MEMORANDUM

Date: February 2, 2017

Subject: U District Rezone Amendments for Consideration

MAP OF PROPOSED AVE REZONE

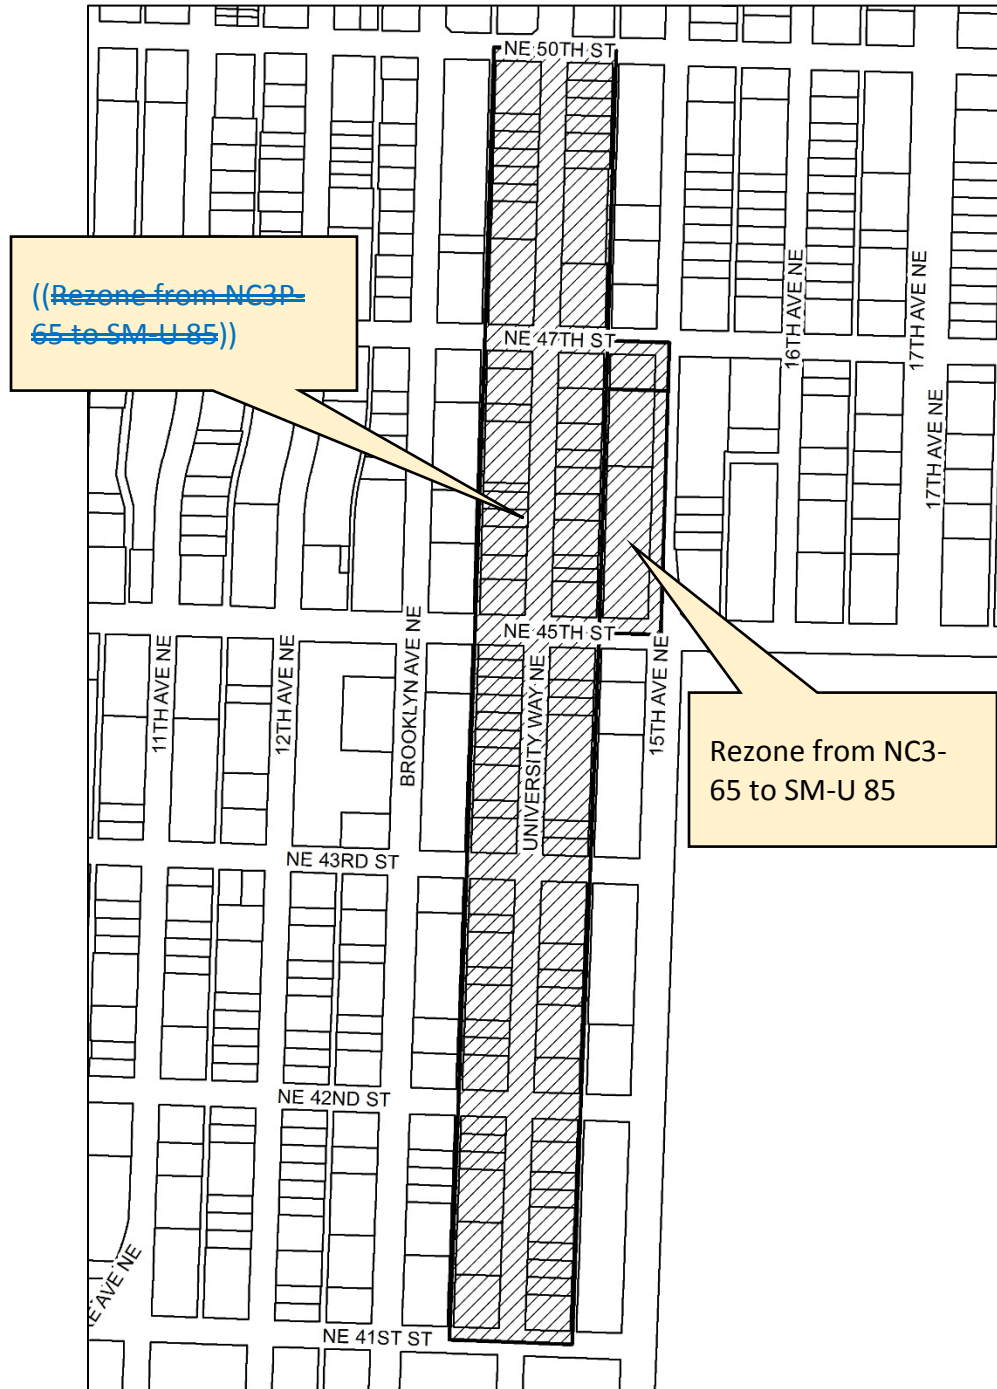
Amendment to remove the proposal to rezone the Ave (University Way NE) between NE 41st Street and NE 50th Street from Neighborhood Commercial 3 with a Pedestrian designation and 65 foot height limit (NC3P-65) to Seattle Mixed-University District with an 85 foot height limit (SM-U 85) and retain the U District Station Area Overlay District.

- *the Official Land Use Map on Page 60, 78, and 79 to maintain the current zoning of properties fronting on University Way NE between NE 41st Street and NE 50th Street.*
- *subsections 23.48.645.C – 23.48.645.F to remove references to the SM-U 85 zone along University Way NE.*
- *the title of Council Bill 118862, Section 1 of Council Bill 118862, Sections 23.47A.012, and 23.47A.013, and Exhibit A2 to Council Bill 118862 to retain the U District Station Area Overlay District. This would require the introduction of a new Council Bill.*

MAP OF PROPOSED AVE REZONE

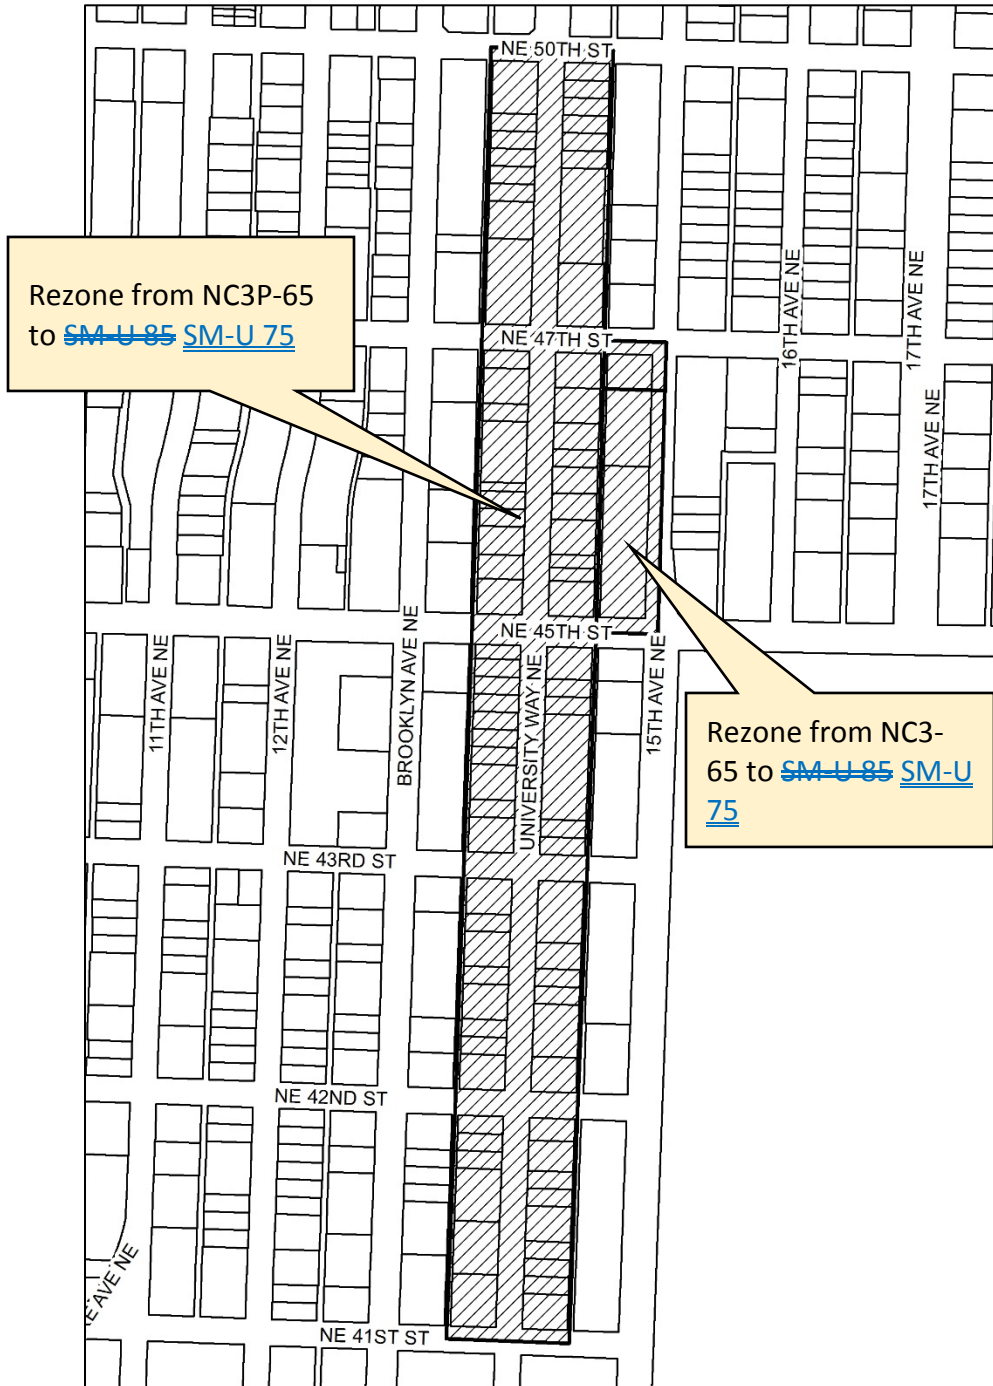
- the Official Land Use Map on Page 60, 78, and 79 to reflect the new zone (see map at end of this attachment)
- subsection 23.48.620.A to incorporate FAR requirements for the SM-U 75 zone (page 78 of [Council Bill \(CB\) 118862](#))
- subsection 23.48.620.B to remove the incentive zoning requirements in the SM-U 75 zone (page 80 of CB 118862)

MAP OF PROPOSED NORTH OF NE 50TH STREET REZONE

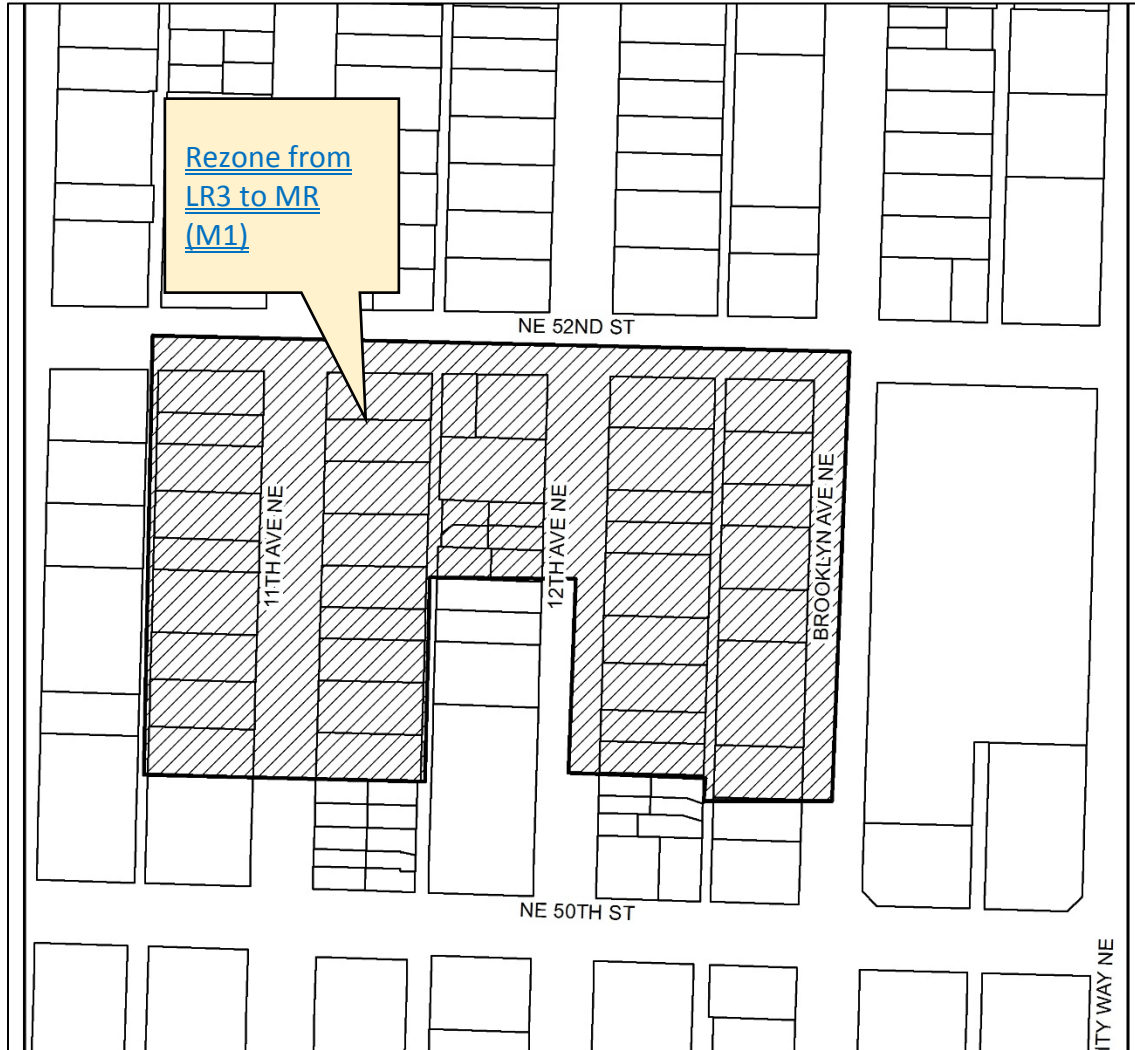
Amendment to rezone the multifamily district between NE 50th Street and NE 52nd Street from LR3 to MR.

This amendment will change the Official Land Use Map on Page 60.

MAP OF PROPOSED REZONE AT BROOKLYN AVE NE AND NE RAVENNA BLVD

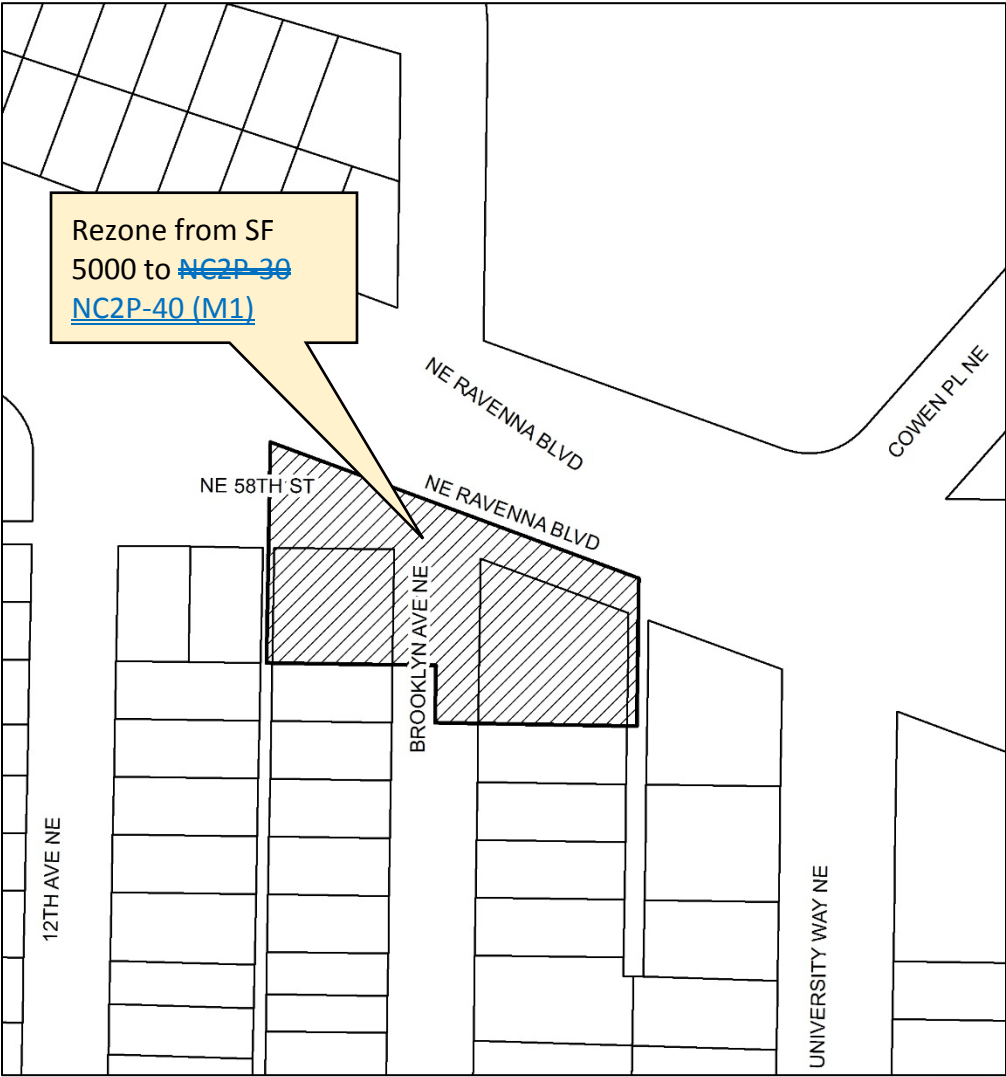
11. Brooklyn Avenue NE and NE Ravenna Boulevard	Increase the heights on the properties on the southeast and southwest corners of this intersection to NC2P-40’ (M1) (Att 14) <i>(Johnson)</i>	This responds to a request from the property owner to provide more flexibility for the site of the Cowan Park Grocery, a long-standing business that is currently non-conforming to the zoning at this location.

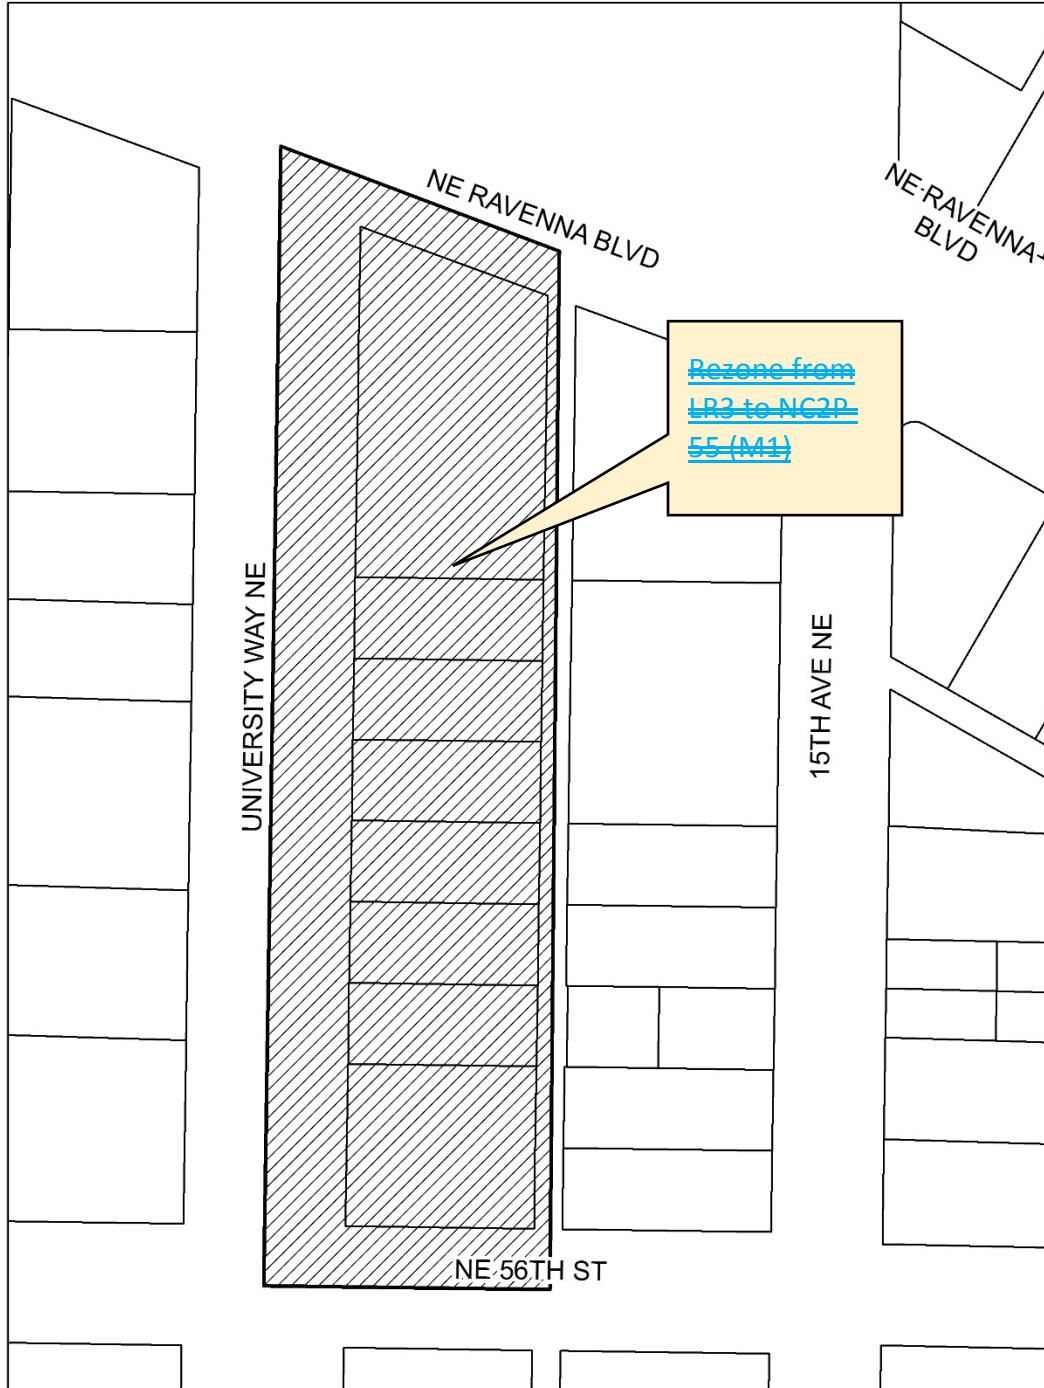
Amendment to remove the proposal to rezone the east side of the block on University Way NE between NE 56th St and NE Ravenna Blvd from LR3 to NC2P-55.

Exhibit A for 23.48.040
Area where transparency and blank facade requirements
apply to structure

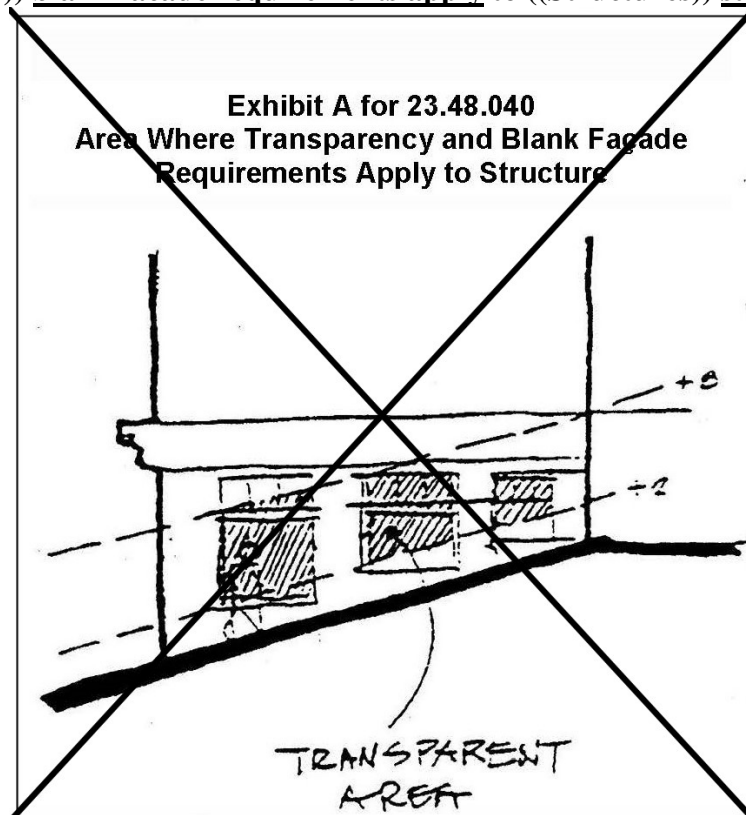
B. Transparency and blank facade requirements. The provisions of this subsection 23.48.040.B apply to the area of a street-facing facade between 2 feet and 8 feet above a sidewalk, as shown on ~~(())~~ Exhibit A for 23.48.040 ~~(() pursuant to subsection 23.48.040.B.1))~~, but do not apply to portions of a structure in residential use or, within the SM-U district, to portions of a structure in use as a light rail transit station.

Exhibit A for 23.48.040
Area ~~((Where Transparency))~~ where transparency and ~~((Blank Facade Requirements Apply))~~ blank facade requirements apply to ~~((Structures))~~ structure

Exhibit A for 23.48.620
Dwelling units and amenity area exempt from FAR

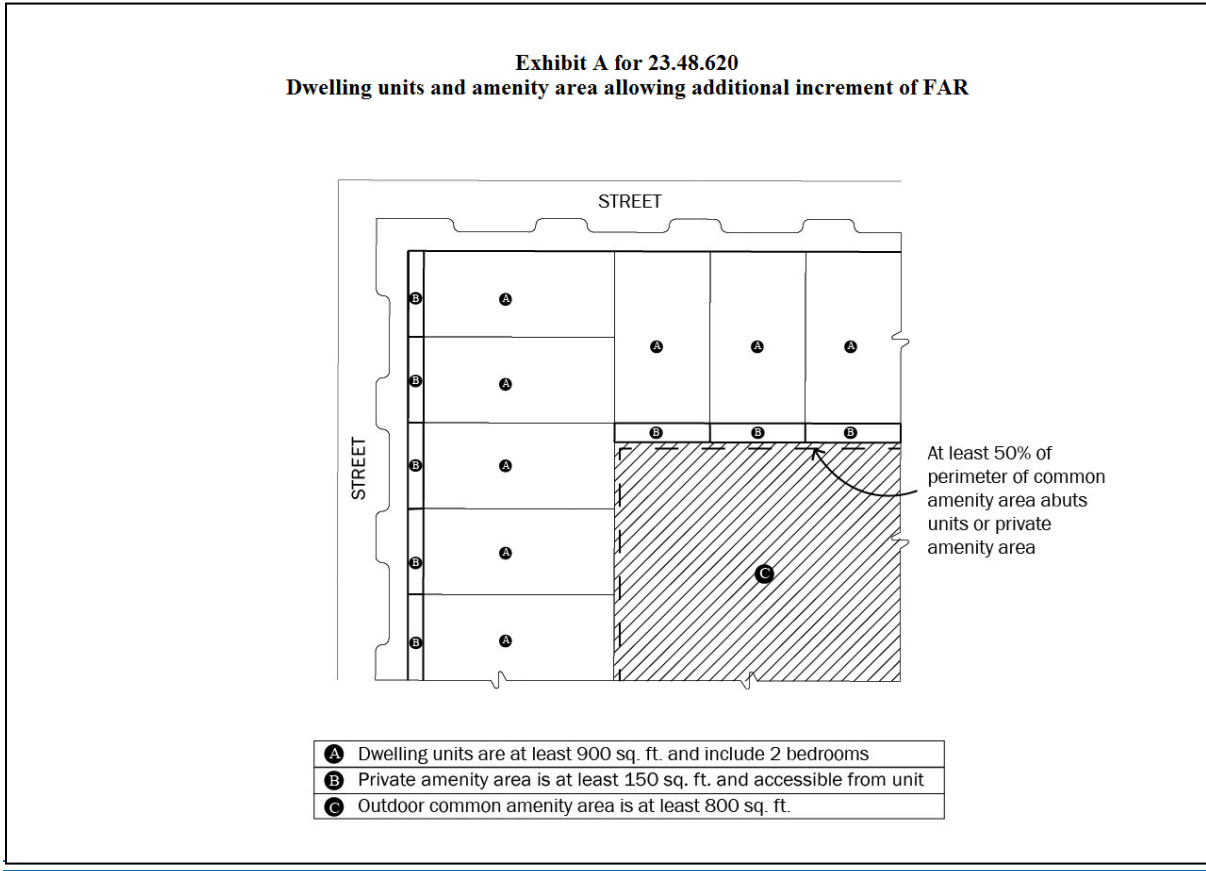
16. Family size units	Increase the maximum FAR limit if 10 (or more) family size units are included with accessible outdoor space (Att 19) <i>(Johnson, O’Brien, Herbold)</i>	In the SM-U zone, up to 0.5 FAR above the base FAR limit would be permitted for projects that include 10 family-size dwelling units with accessible outdoor space. Depending on lot size and configuration, increasing the maximum FAR may be a greater incentive to provide family sized units.
